Business Paper

Camden Local Planning Panel
Electronic Determination

20 July 2022

SUBJECT: DA/2022/225/1 - CONSTRUCTION OF A SINGLE STOREY DWELLING HOUSE - 23 GLEESON RISE, ORAN PARK
FROM: Manager Statutory Planning
EDMS #: 22/281741

Figure 6: Five metre maximum building height limit compared to roof pitches

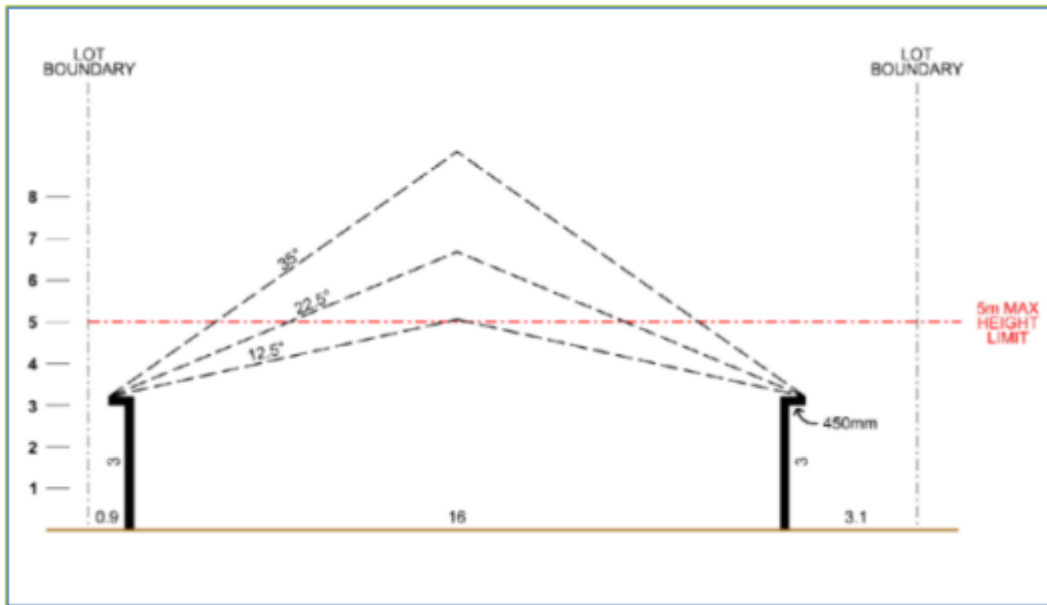
This height of buildings development standard hinders the ability for a proposed dwelling house to comply with the existing site-specific controls in Camden Growth Centre Precincts DCP and Schedule 4 Catherine Fields (Part) Precinct.

Dwelling houses with hipped and gabled roof forms (with a roof pitch greater than 12.5 degrees) will inherently exceed the 5m building height development standard given the relative size and width of the properties, coupled with the larger building footprint required for single storey dwellings. This is illustrated in the following Figures 6 and 7. Council’s development controls for dwelling houses in this area require a minimum roof pitch of 22.5 degrees.

Figure 6. Indicating roof pitch, lot width and building height.

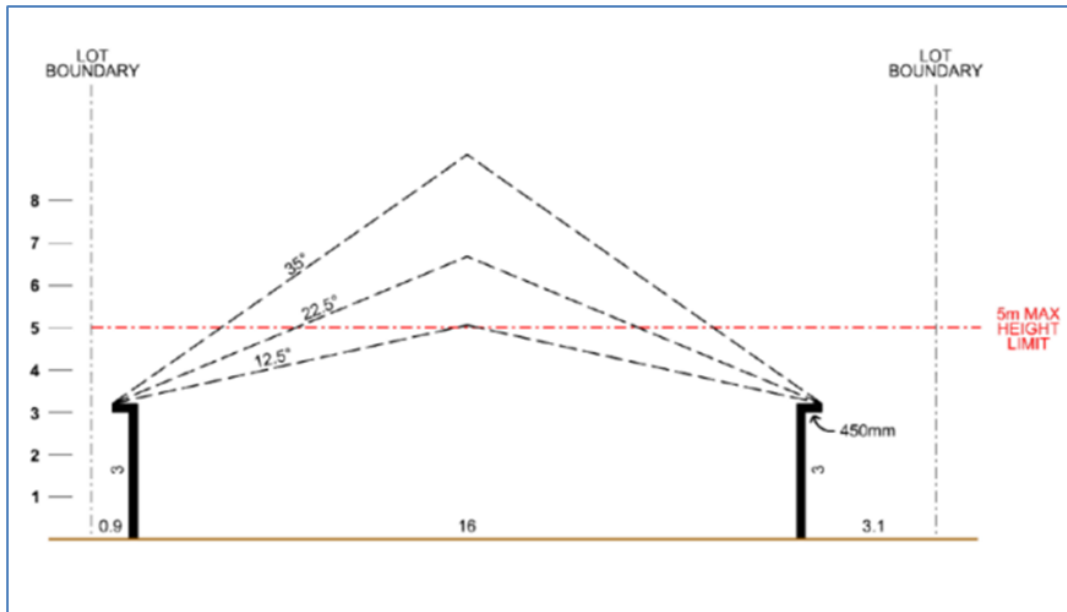
This height of buildings development standard hinders the ability for a proposed dwelling house to comply with the existing site-specific controls in Camden Growth Centre Precincts DCP and Schedule 4 Catherine Field (Part) Precinct.

Dwelling houses with hipped and gabled roof forms (with a roof pitch greater than 12.5 degrees) will inherently exceed the 5m building height development standard given the relative size and width of the properties, coupled with the larger building footprint required single storey dwellings. This is illustrated in Figures 6 and 7 below. Council’s development controls for dwelling houses in this area require a minimum roof pitch of 22.5 degrees.

Image 8 – Building height envelopment control (front façade)

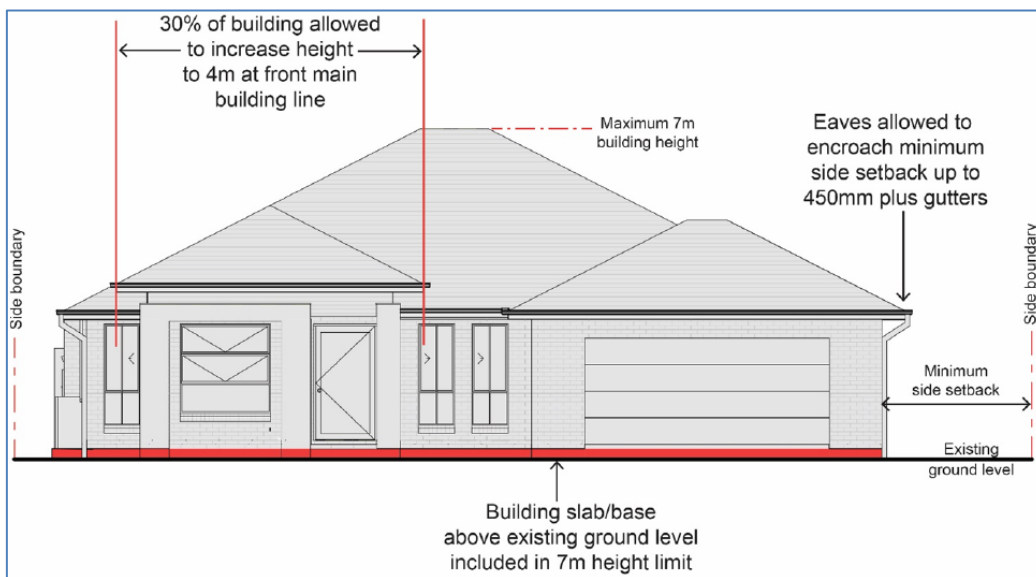
The proposed dwelling house generally complies with the above requirements however the front façade is not fully contained within the building height envelope (as recommended by Heritage NSW). The building height envelope requires entry features, porticos and other similar building elements to not exceed 4m in height and that such features must not exceed 30% of the building width / front façade. In this instance 42% of the building width / front façade is to consist of decorative design elements, being the gabled roof elements on the front elevation and the proposed gables are greater than 4 metres in height (refer image 8 and 9 below).

The proposed variation is considered reasonable for the following reasons:

SCALE: A3	DATE: 3.08.2021
DRAWING No: 6488-1	SHEET: 11/12
	ISSUE: M

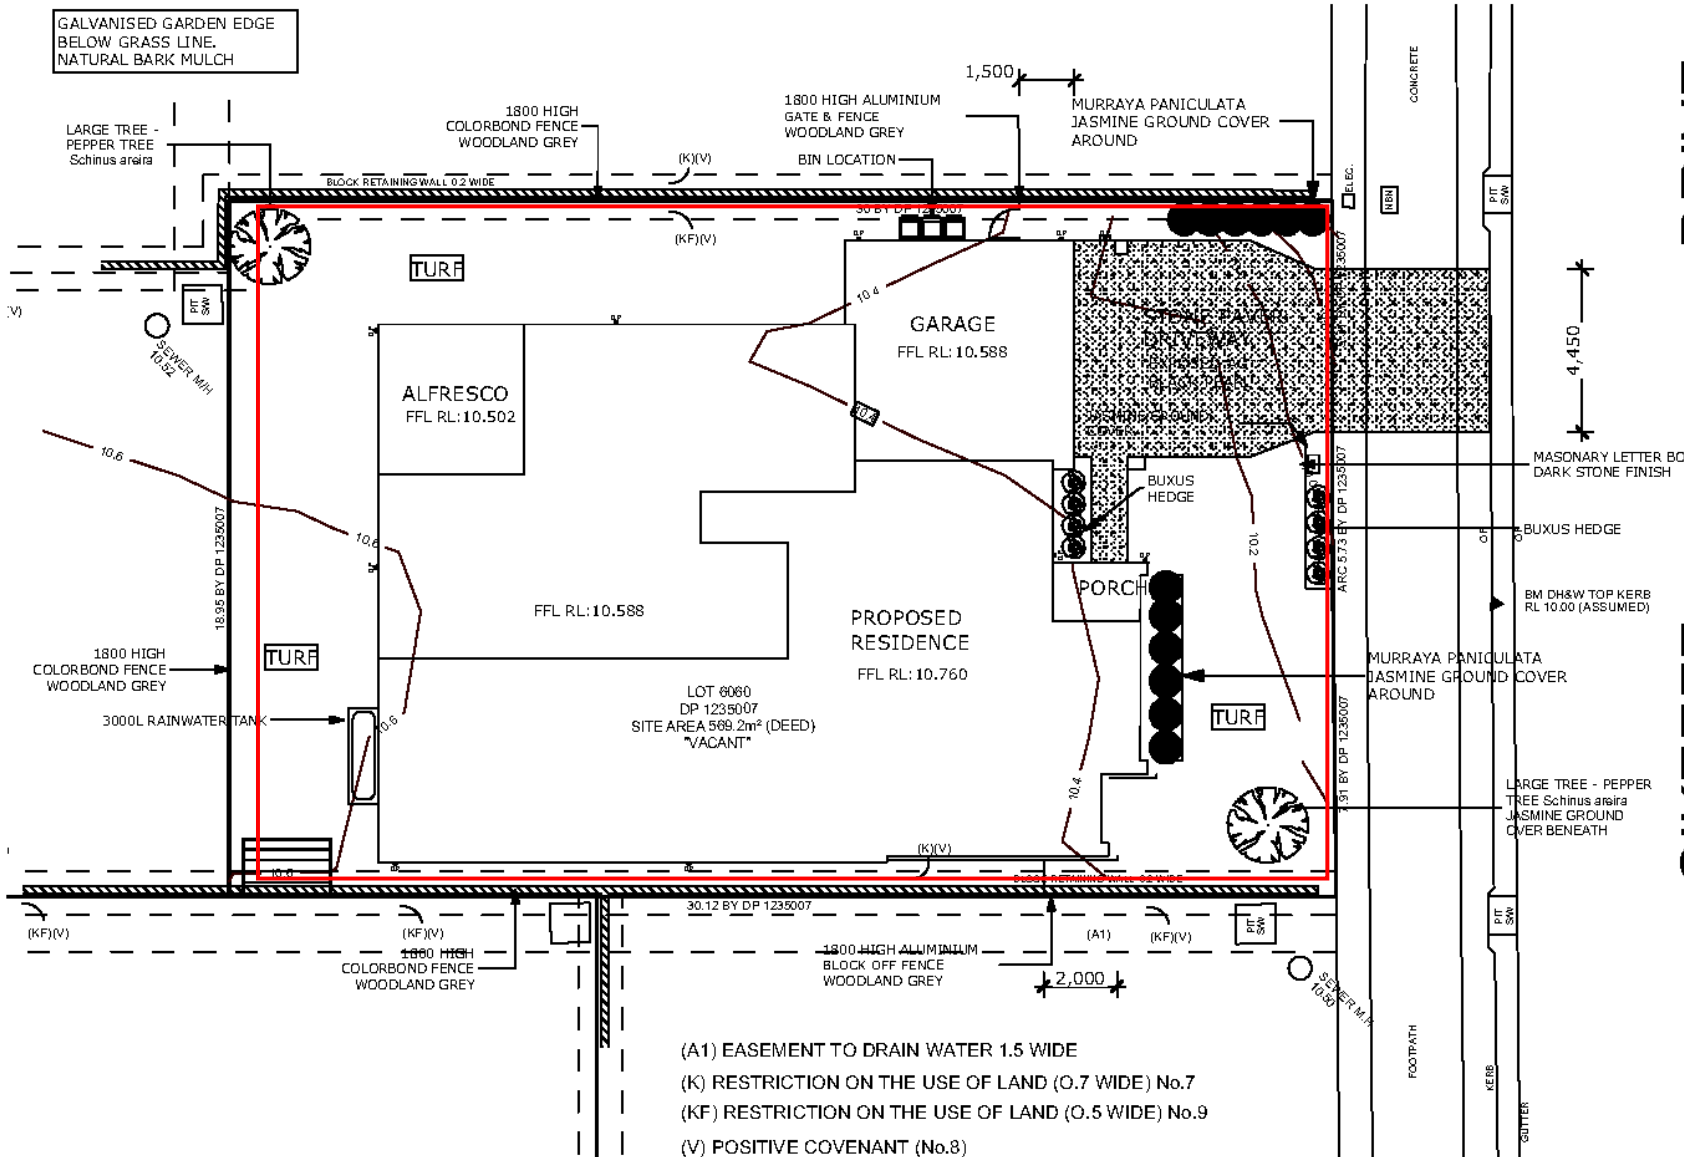
- (2) **Modified Documents and Plans** - The development shall be modified as follows:
- a) The Concept Landscape plan is to be amended to indicate at least two (2) alternative trees with large canopies in accordance with the preferred species listed at **Appendix C**, indigenous species are preferred.

Amended plans or documentation demonstrating compliance shall be provided to the certifier and Council prior to the issue of a Construction Certificate.
